CEFCO SPRINGHILL MOBILE SUBDIVISION

The plat illustrates the proposed 1-lot, 1.4± acre subdivision which is located at the Northwest corner of Springhill Avenue and Mobile Street within Council District 1. The applicant states that the subdivision is served by city water and sanitary sewer. The purpose of this application is to remove a condition of a previous Subdivision granting tree preservation status to the 66" Live Oak tree on the property that was approved at the January 7, 2016 Planning Commission Meeting.

DETAIL SITE PLAN

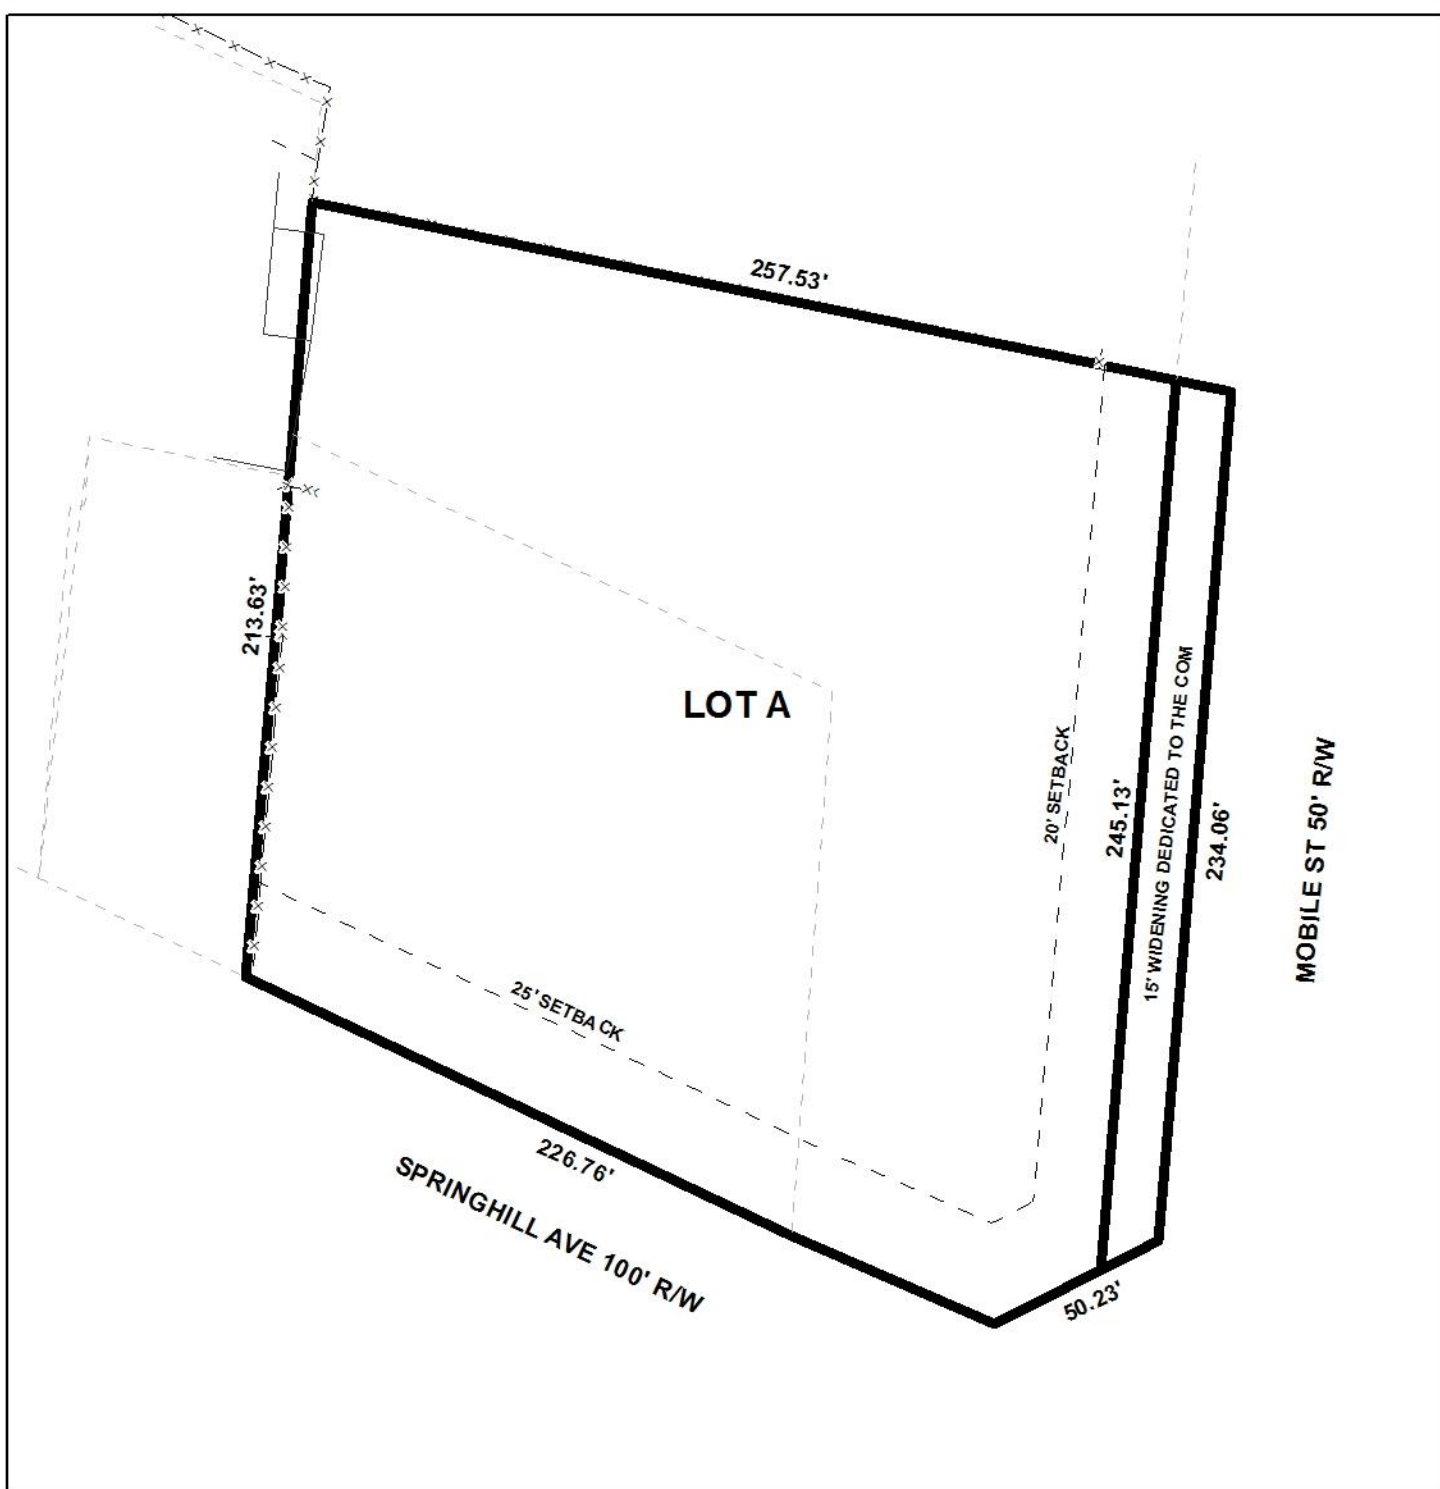
Being that the subject site has frontage along both Springhill Avenue and Mobile Street, the applicant must ensure that the property lines at this intersection provide a compliant curb radius. The Final Plat, if approved, should be revised to illustrate a dimensioned curb radius in compliance with Section V.D.6. of the Subdivision Regulations.

The Subdivision Regulations require a minimum distance of 25' setback from the front property line to all buildings on site. The plat depicts a minimum setback line distance of 25' along Springhill Avenue; however only a minimum setback line distance of 20' is shown along Mobile Street, which is allowed by the Zoning Ordinance.

Springhill Avenue is an ALDOT managed facility. As a means of access management, the note should be retained on the Final Plat stating that the proposed lot is limited to one curb cut to Springhill Avenue and one curb cut to Mobile Street, with the size, location and design to be approved by Traffic Engineering and conform to AASHTO standards.

In an effort to justify the removal of the 66" Live Oak tree, the applicant submitted 5 proposed site plans for redevelopment of the site. Each of the proposed site plans depict various layouts as it pertains to the fuel dispensers and canopy location; yet, other site improvements, such as the building, remained unchanged in each of the five site plans submitted. Reducing the size of the building by 1,000 to 2,500 square feet, in addition to reducing the size of the canopy and eliminating 1-2 fuel dispenser stations, will significantly reduce the number of parking spaces needed; thus, providing more available space to work with on site. Additionally, by altering the existing access driveway along Mobile Street, as opposed to creating a new access driveway, compliant vehicular flow and accessibility, as well as preservation of the 66" Live Oak tree, can be achieved.

- 1) No justification was submitted supporting a deviation from state and local tree preservation laws that would require the removal of the 66" Live Oak tree due to disease or impending danger; and
- 2) The site plan can be reconfigured in a manner such that the size of the proposed building and canopy could be decreased, in addition to the elimination of 1 to 2 fuel dispenser stations, which will allow for increased vehicular flow and accessibility, as well as more flexibility in allowing the preservation of the 66" Live Oak tree; all possible options have not been exhausted.
